Hapeville
georgia

DESIGN REVIEW COMMITTEE

July 17, 2024 6:00 PM

AGENDA

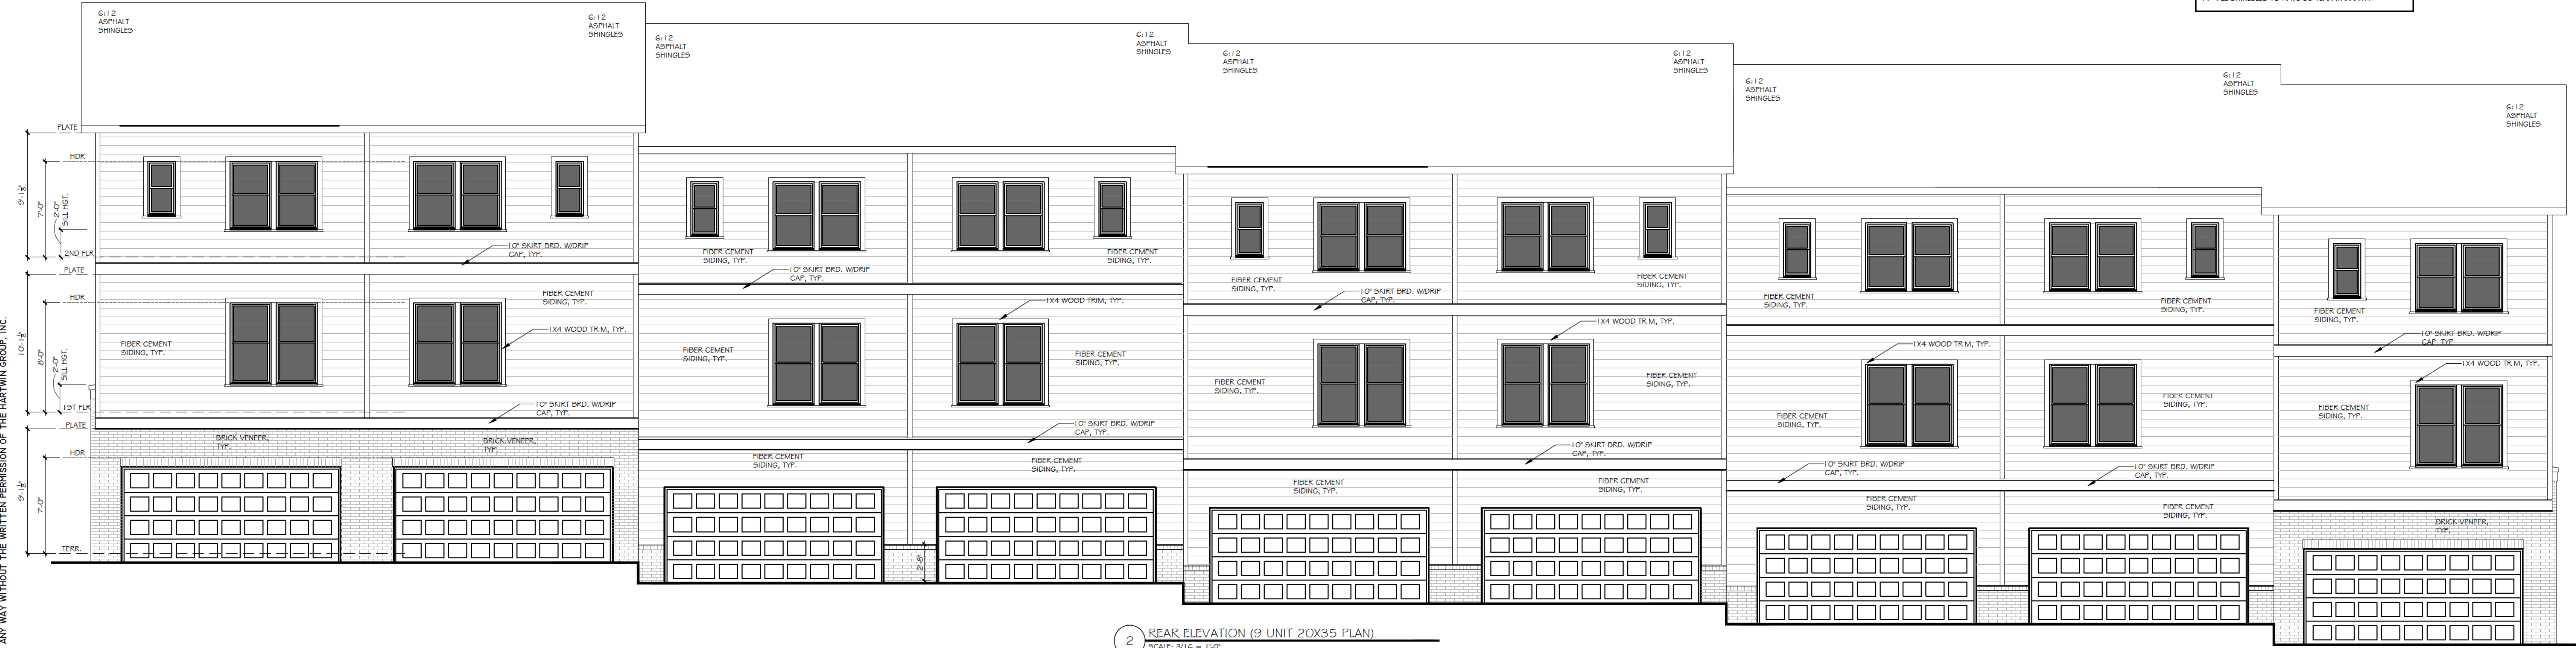
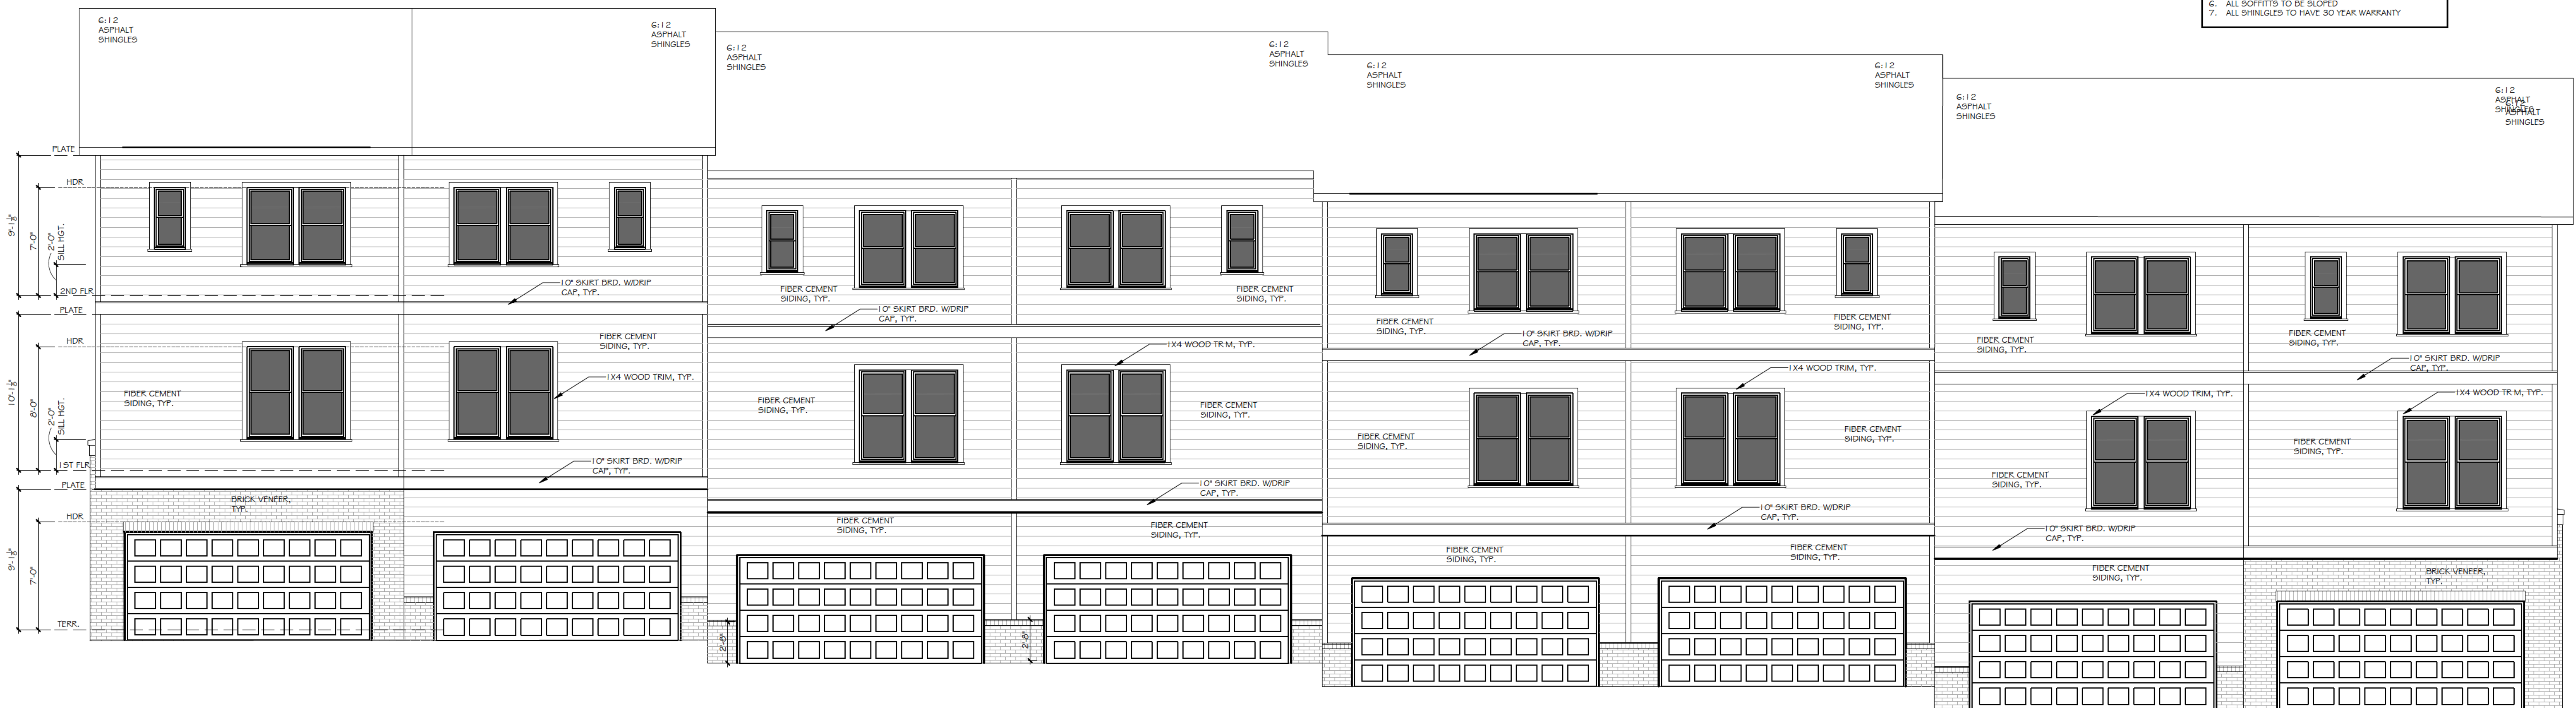
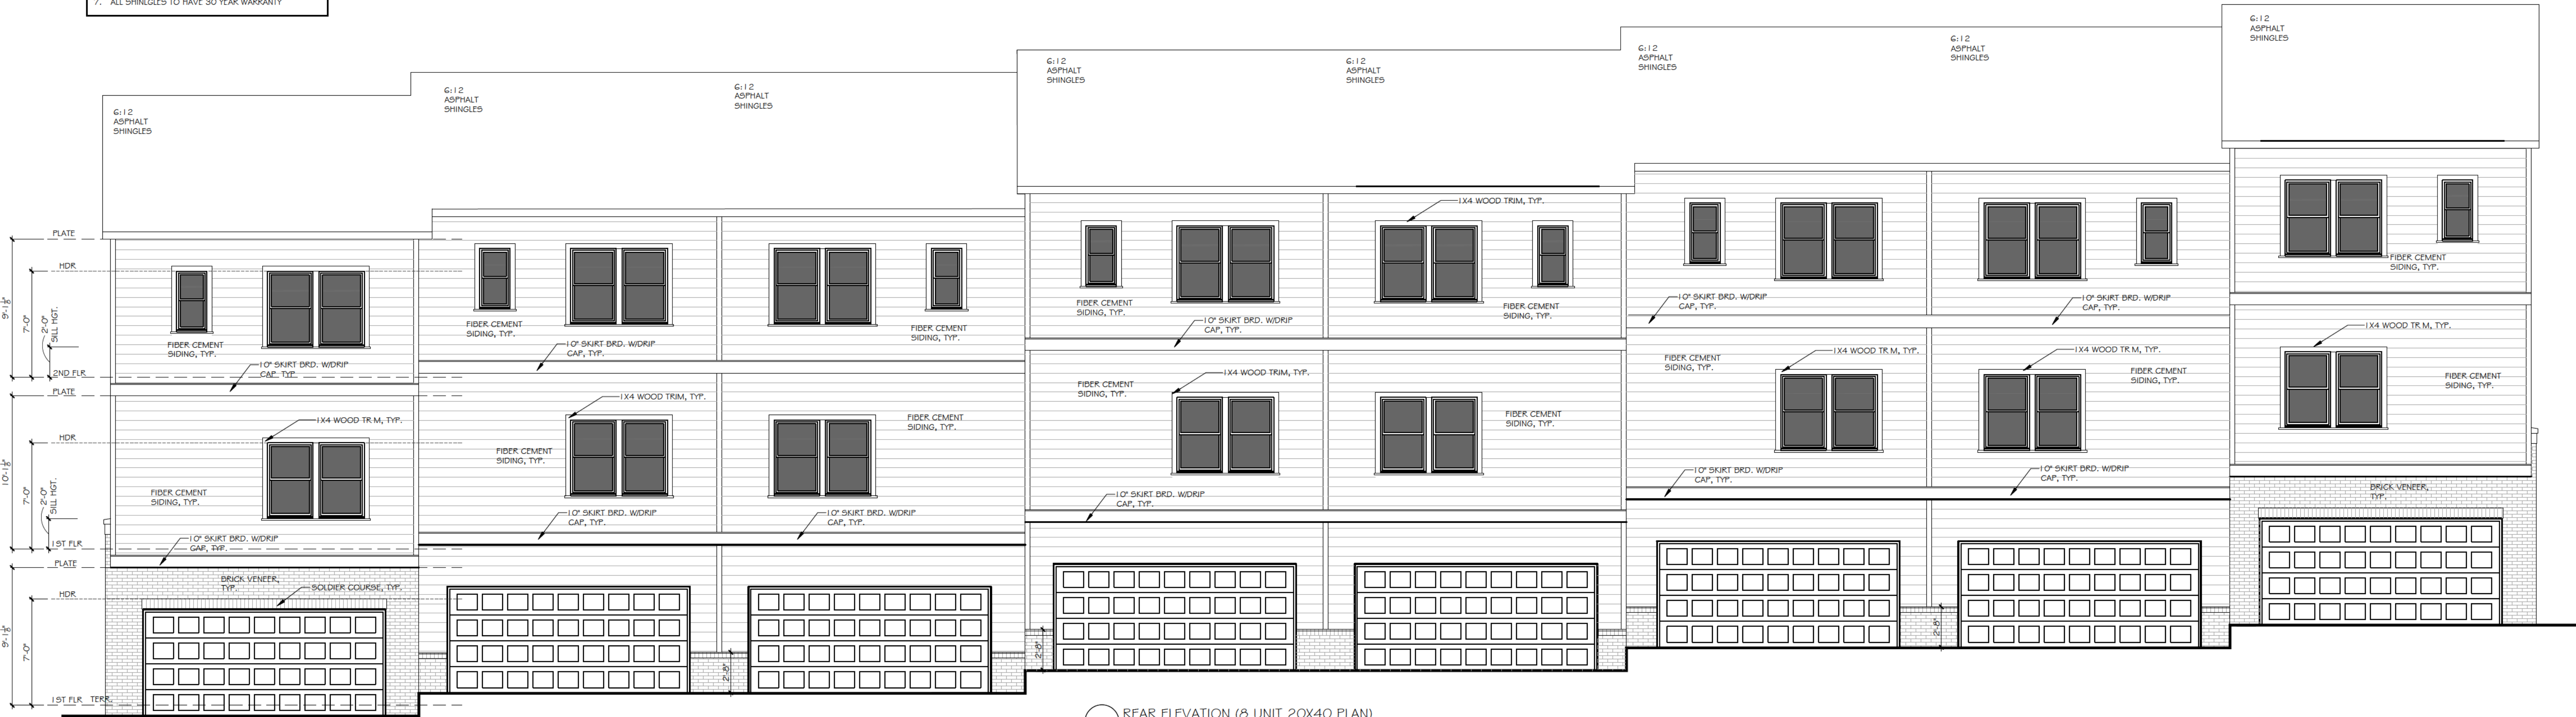
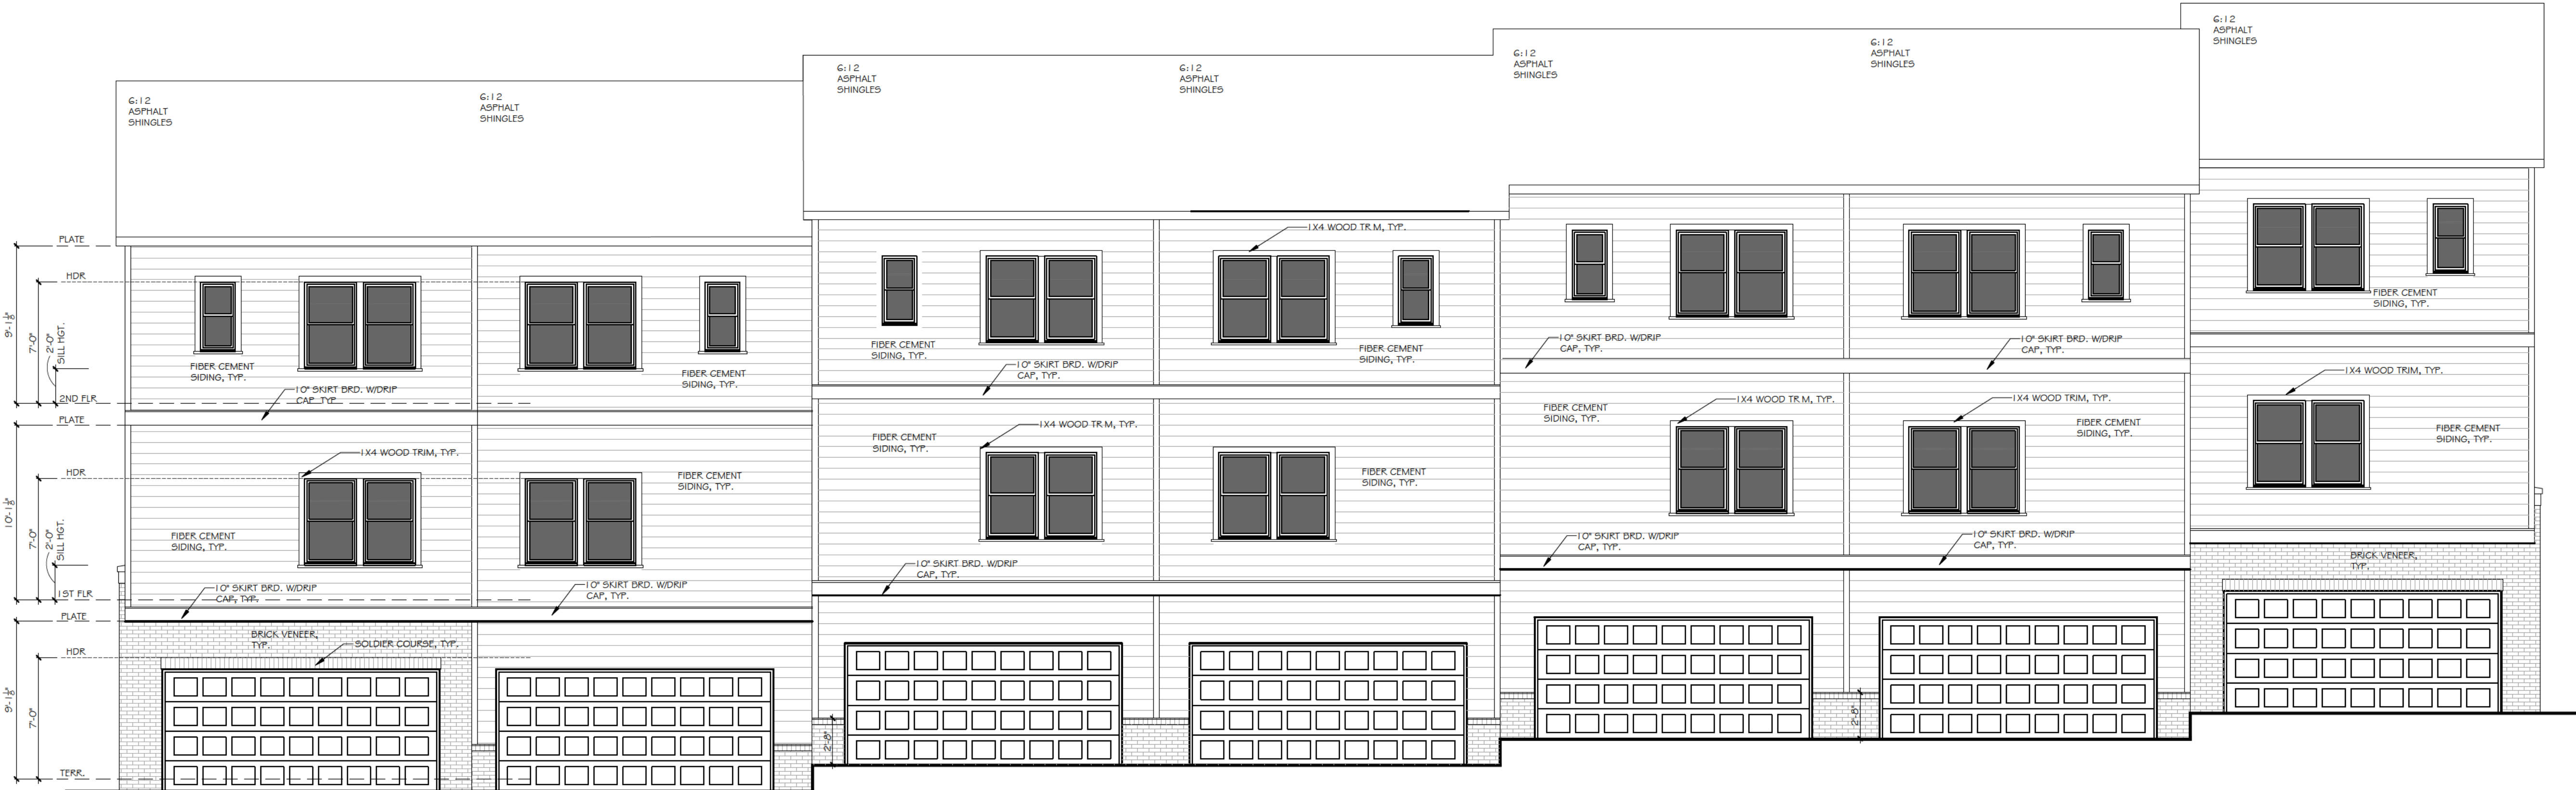
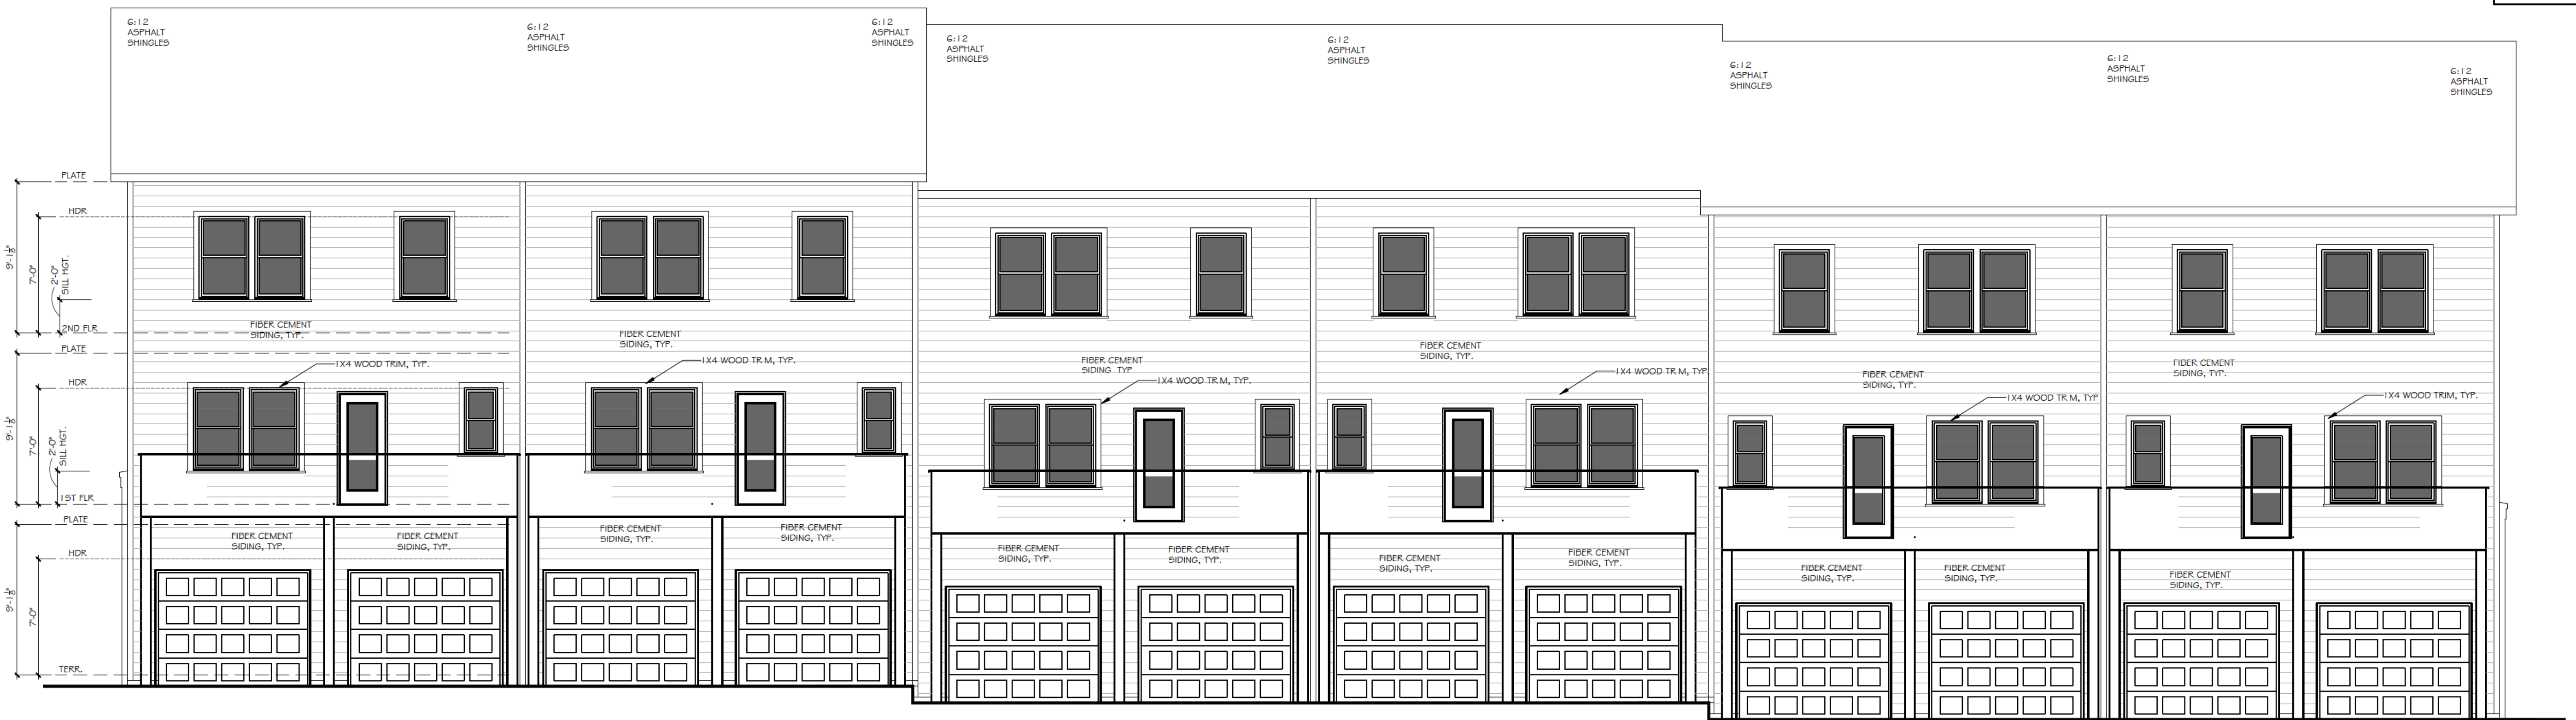
- **Building numbers should be provided.**
Partially addressed. Include unit numbers on each unit.
- Window recess detail should be provided.
Addressed.
- Trim detail should be provided for mullions.
Addressed.

- **Note on plans indicate: ALL ROOF PLAN OVERHANGS TO BE 12" UNLESS NOTED OTHERWISE.**
Overhangs may NOT be less than 12"
- b. Discussion on building height not exceeding 45-ft (zoning requirement). Applicant agrees to define structure heights on plans.
Addressed. Per design standards definitions "Height. A vertical measurement from the average adjacent grade of the ground to the ridge line of a structure." The height shown on the plans from the adjacent grade is 43' 10"

- c. Change bird-box soffits to sloped or Queen Anne style soffits.
Addressed
- d. **Note material of any decking on plans**
Not addressed.
- e. Third Row (units 33-38) wrap brick around corners at water table and in entry door recesses on front facade
Addressed

- f. **Indicate handrails on Third Row units as needed**
Not addressed as grade is not shown.
- g. Add additional windows on left and right elevations as discussed
Addressed
